POWERTECH (USA) INC.

RE: Revised Technical Report (TR); Powertech (USA) Inc.'s Proposed Dewey-Burdock Project; Docket No. 40-9075

CHANGE INDICES

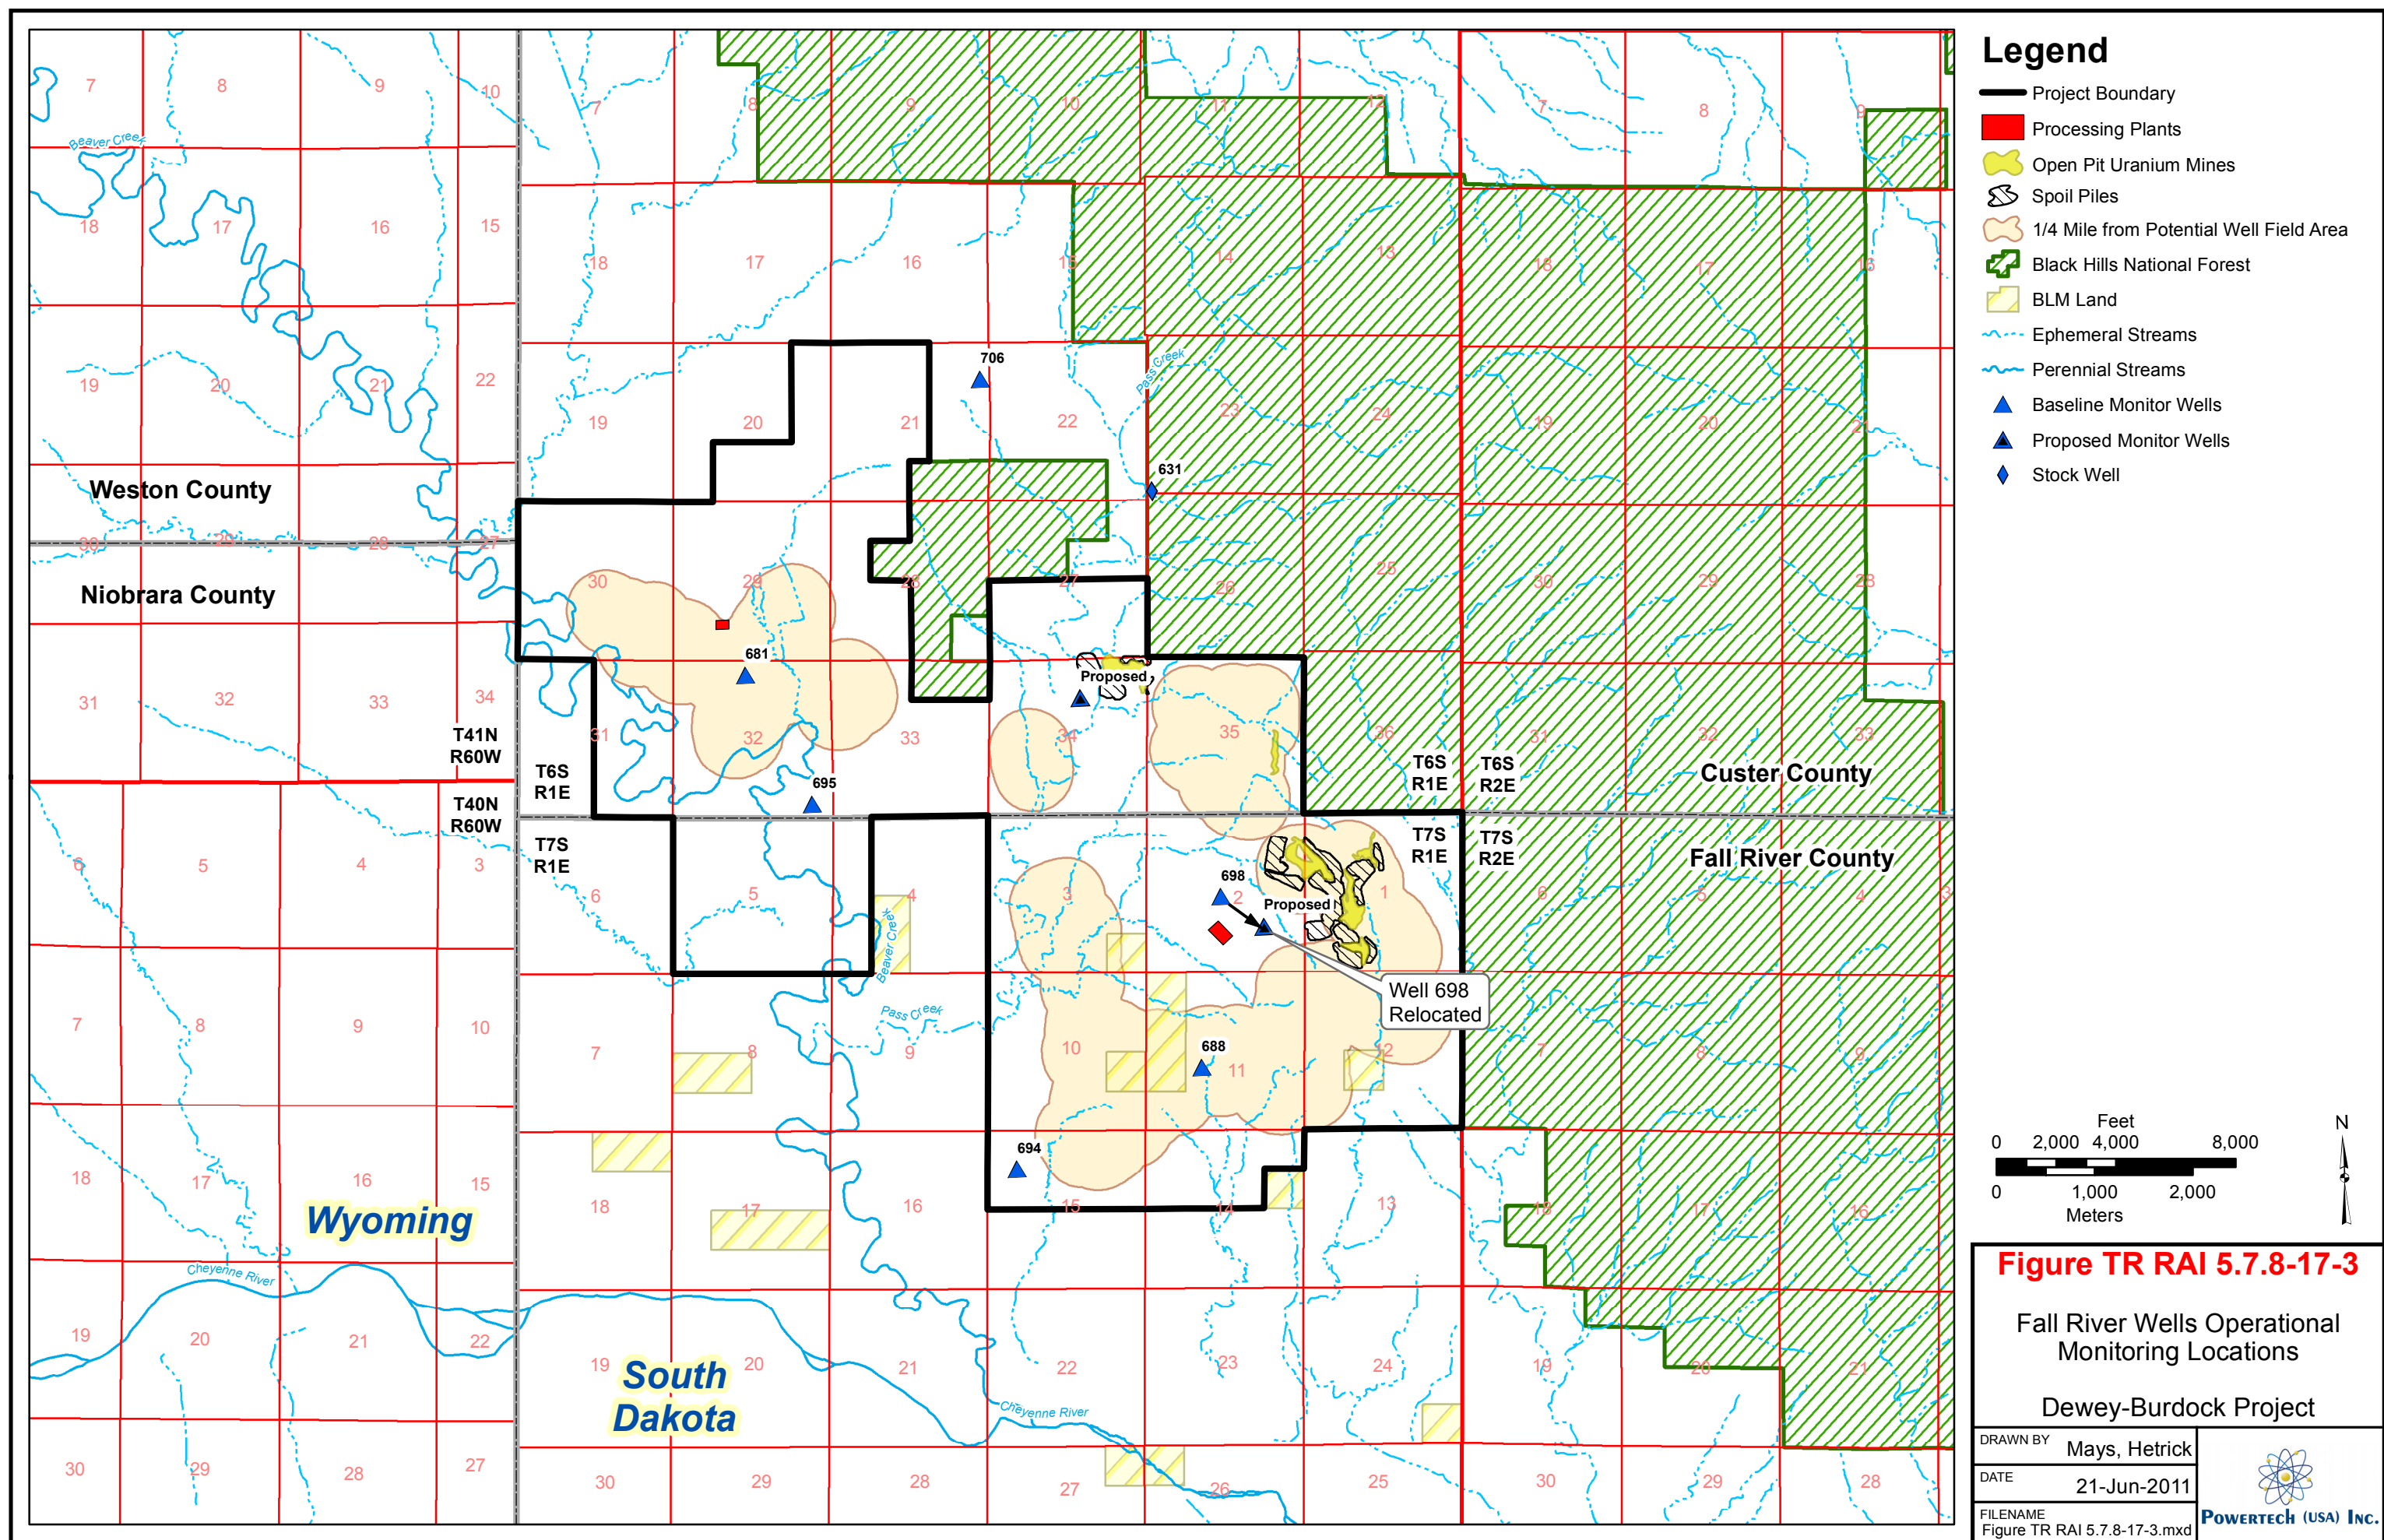
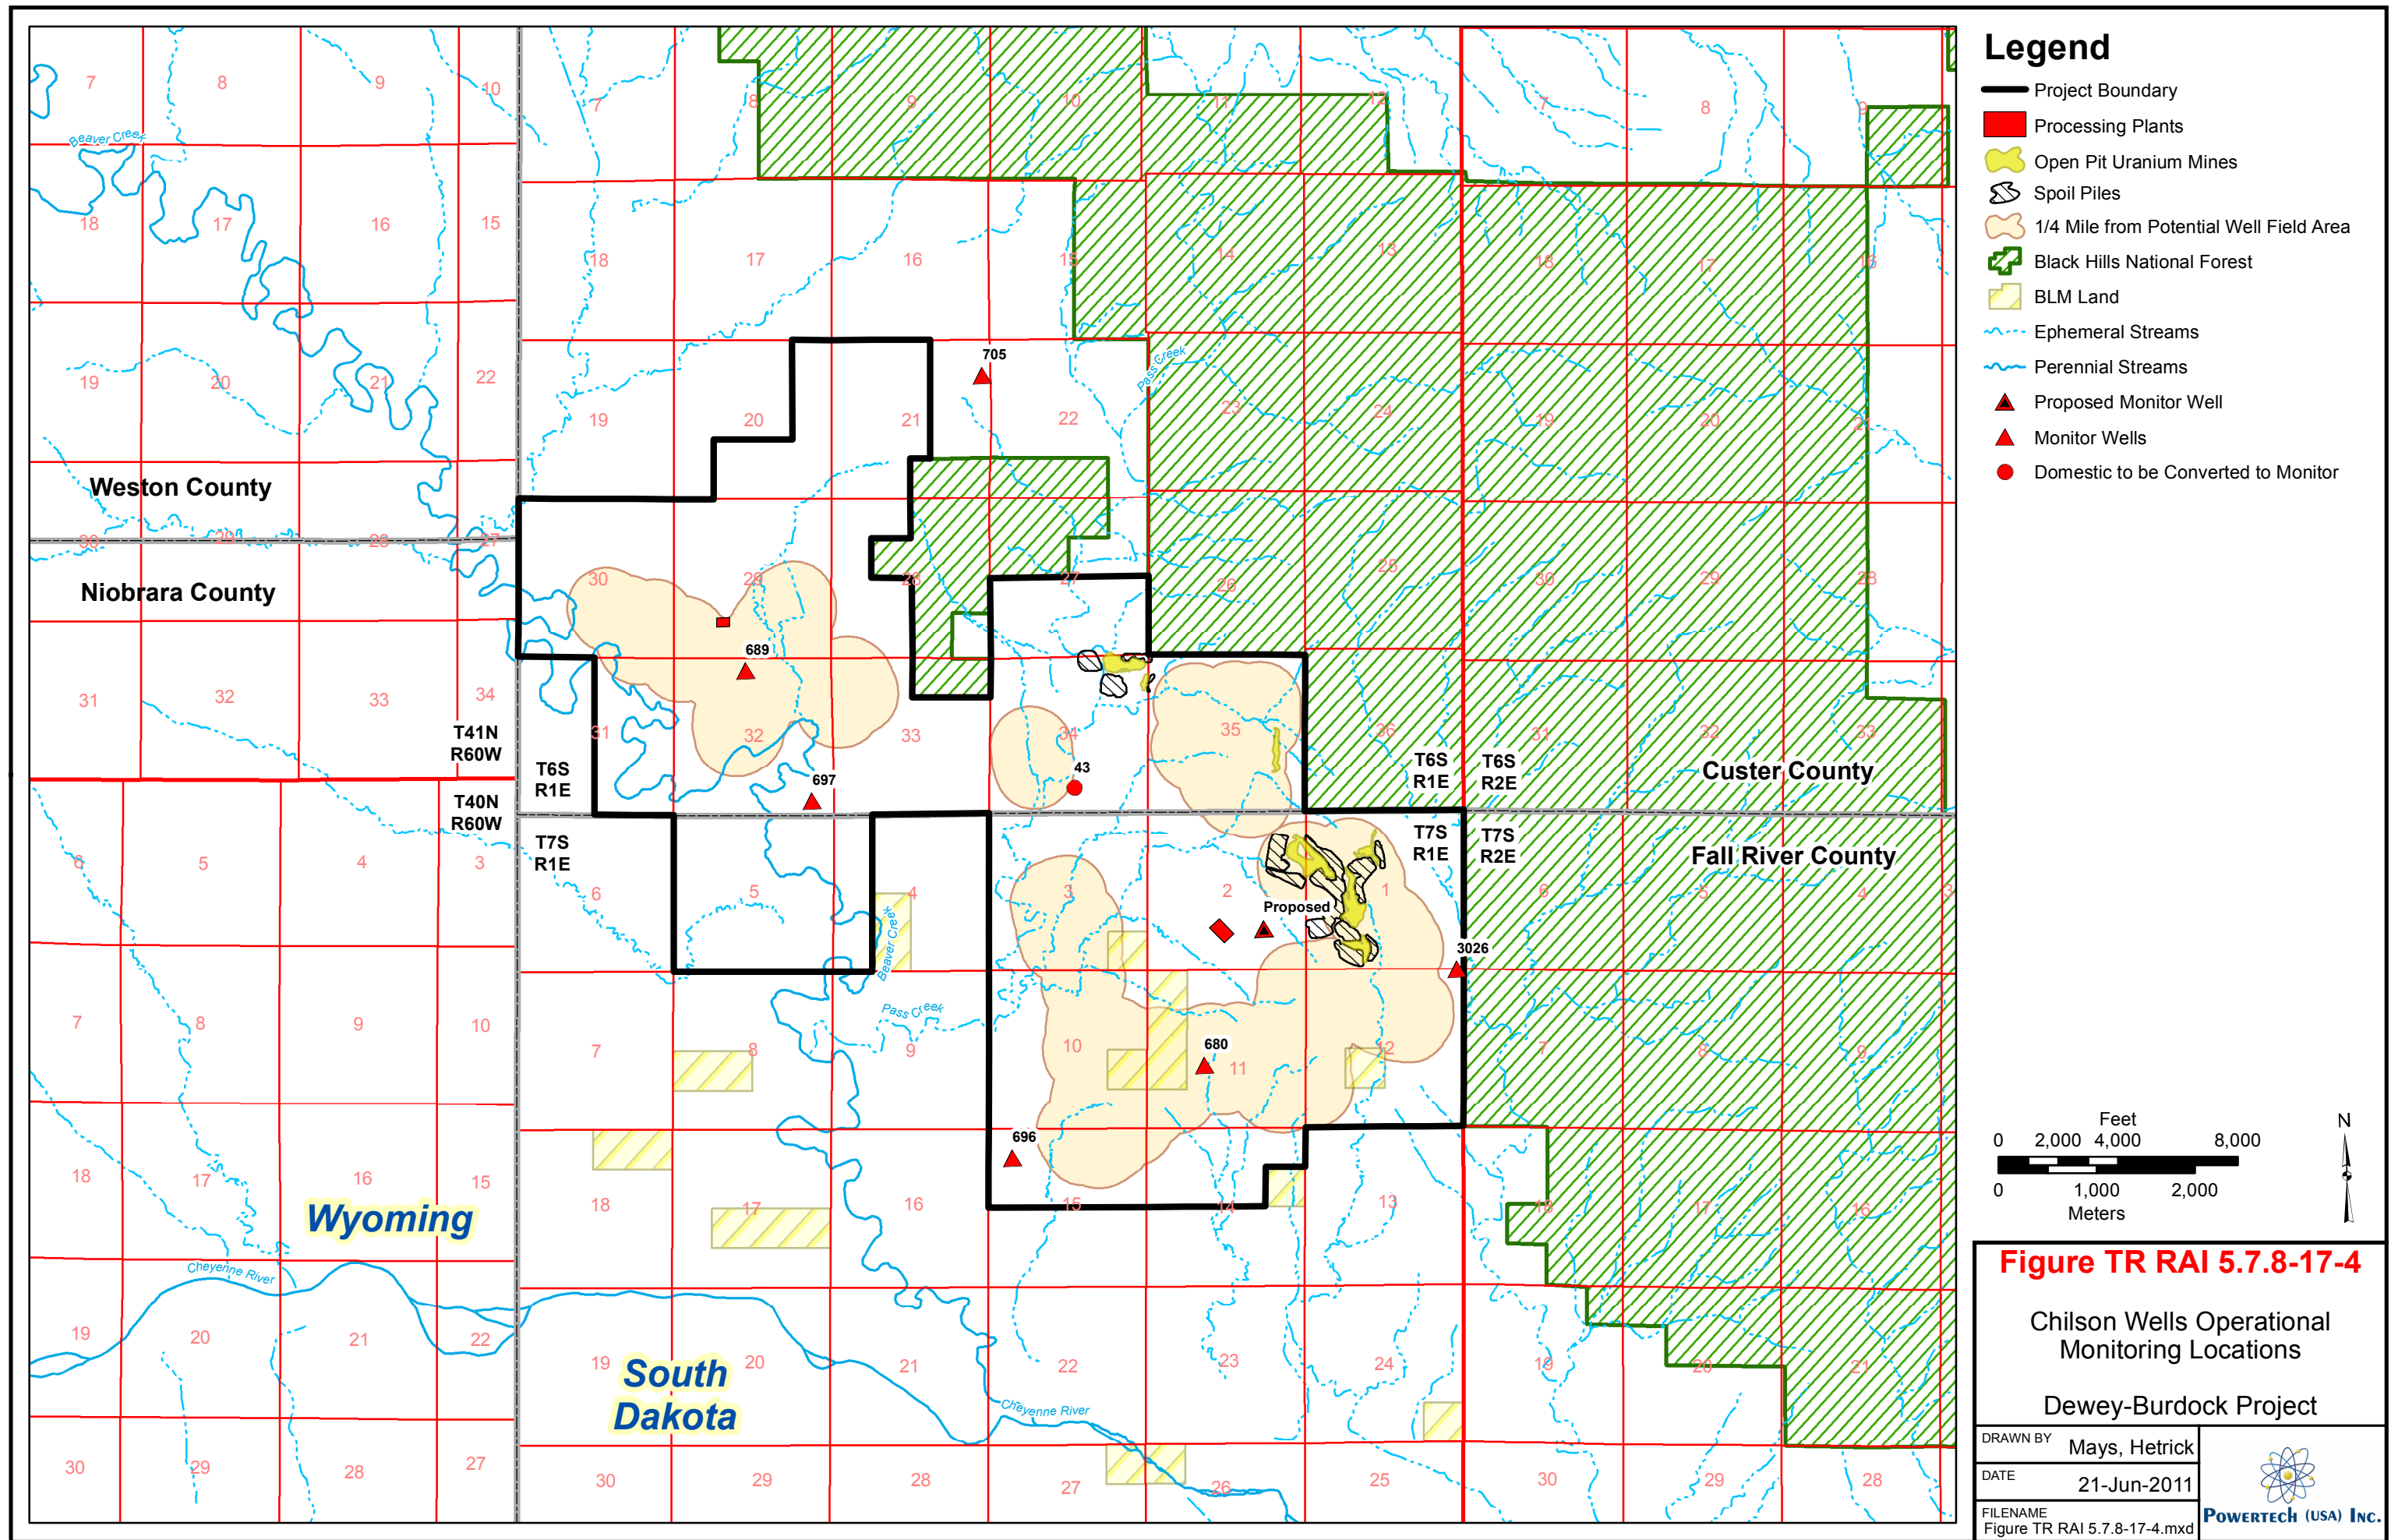
Section 5.7.8 of the TR states, "Quarterly samples will be collected from drinking water and livestock wells, included in the groundwater sampling sites as shown in Figure 5.7-10." This statement implies there are more proposed well sampling locations than what is shown in Figure 5.7-8. NRC staff notes that numerous Inyan Kara wells in Appendix 2.2-A are close to well fields within the license boundary and are not included in Figure 5.7-10. Please specify all water well sampling locations.
